PRODUCT CHANGE NOTIFICATION

CLASSIFICATION OF CHANGE: TOOLING CHANGE FOR 744W SERIES RECEPTACLES AND 744W-00/002 OBSOLETE

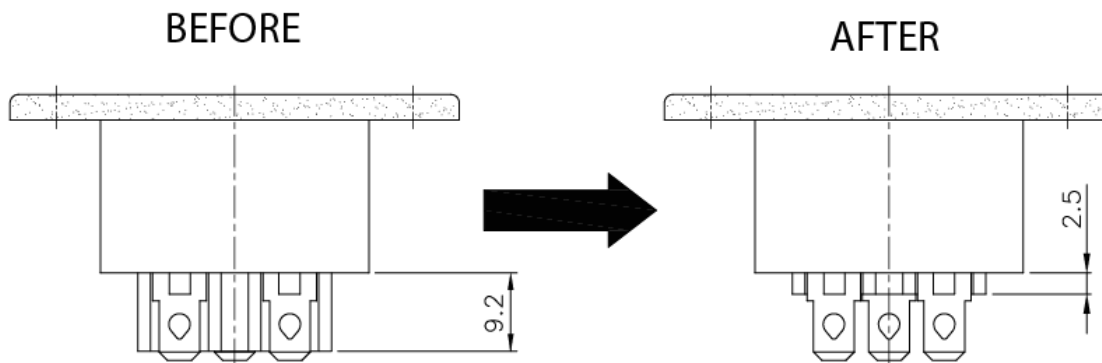
DUE TO UPDATED AGENCY CERTIFICATIONS QUALTEK PART NUMBERS 744W-00/03 AND 744W-00/04 HAVE RECEIVED A REDUCTION OF PLASTIC INSULATION HEIGHT BETWEEN THE TERMINALS ON THE REAR OF THE RECEPTACLE AS SHOWN IN THE DIAGRAM BELOW:

THIS MODIFICATION WILL NOT CHANGE THE FUNCTIONALITY, SAFETY, OR USE OF THIS PRODUCT IN ANYWAY. THE PRODUCT WILL FUNCTION 100% THE SAME, AND THE REDUCTION OF THE INSULATION WILL ALLOW FOR EASIER INSTALLATION.
